PRODUCT SERVICE BULLETIN

No. 200

UNIT MODEL NUMBER:	ALL GEN-SETS
UNIT SERIAL NUMBER:	SEVERAL
COMPONENT AFFECTED:	LOW COOLANT BOARD
AFFECTED DATES:	8/11-8/14/00
REASON FOR NOTIFICATION:	CIRCUIT CHANGE

CONVERSION FROM "OLD" STYLE ISOLATION TRANSFORMER/LOW WATER LEVEL BOARD TO "NEW" STYLE BOARDS ON KASSEC EQUIPPED UNITS

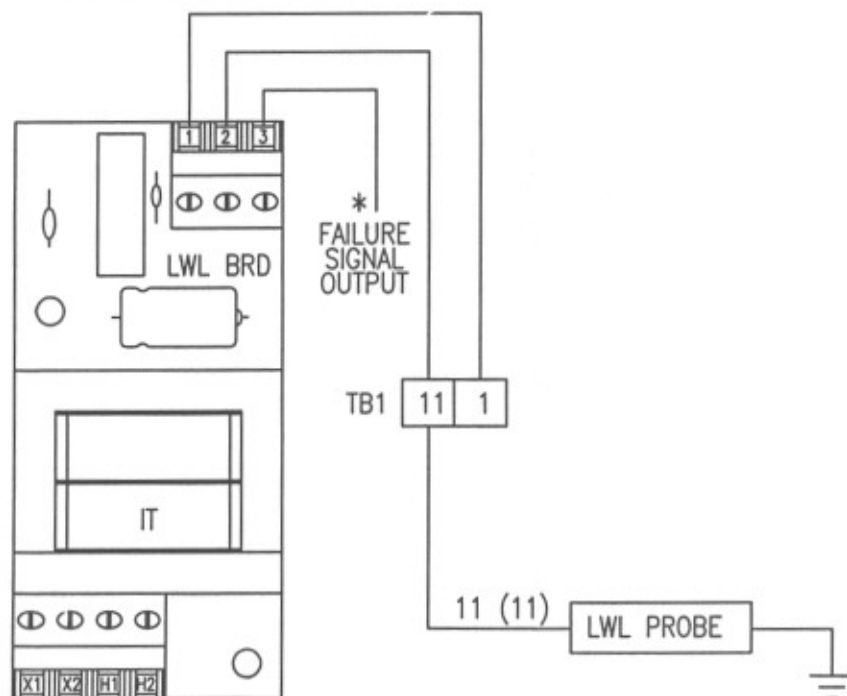
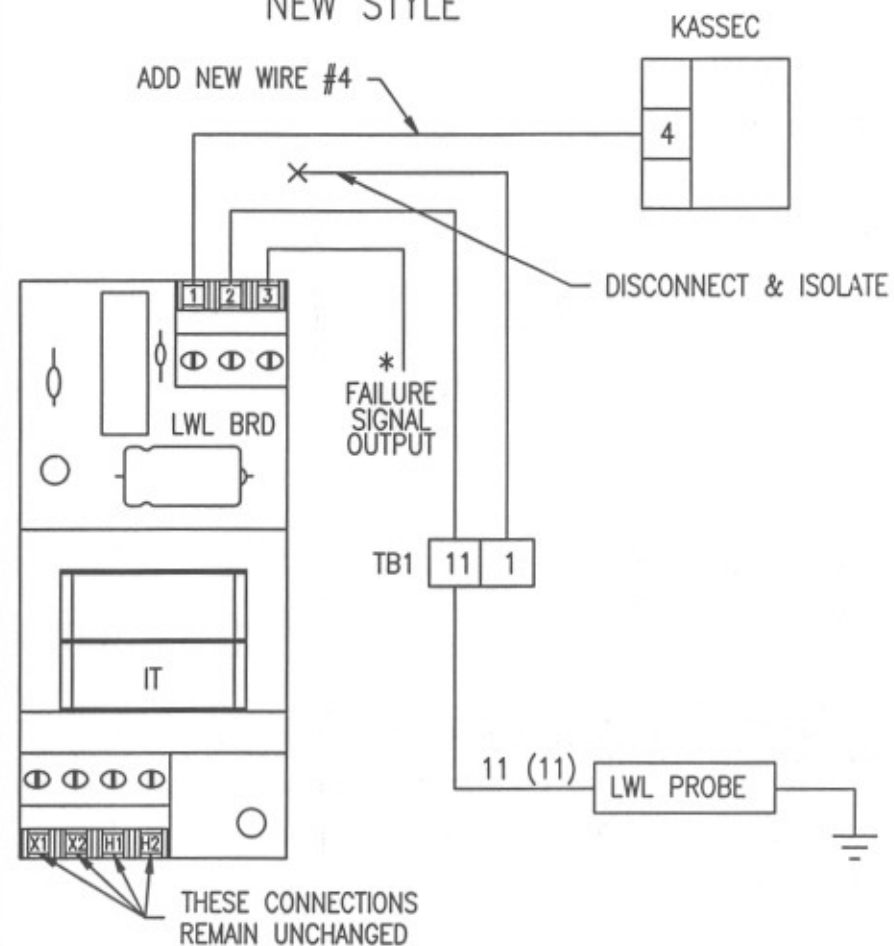
On units shipped from the factory between the affected dates above, there may be a need to change the power supply connection to the low coolant circuit board. This change is required due to a change on the circuit board for the low coolant level only, this circuit change incorporated a latching circuit that will require resetting of the input power to clear the fault after a low coolant shutdown. If this change is not made, when low coolant fault occurs, the fault can only be cleared by removing battery positive from the control panel. Please refer to the attached drawing for wiring instructions.

1. DISCONNECT & ISOLATE WIRE #1 FROM LOW WATER BOARD TERMINAL 1 (IT 1)
2. RUN REPLACEMENT WIRE #4 FROM LOW WATER BOARD TERMINAL 1 TO ENGINE CONTROL (KASSEC) TERMINAL 4
3. TIE STRAP WIRE #4 TO EXISTING HARNESS
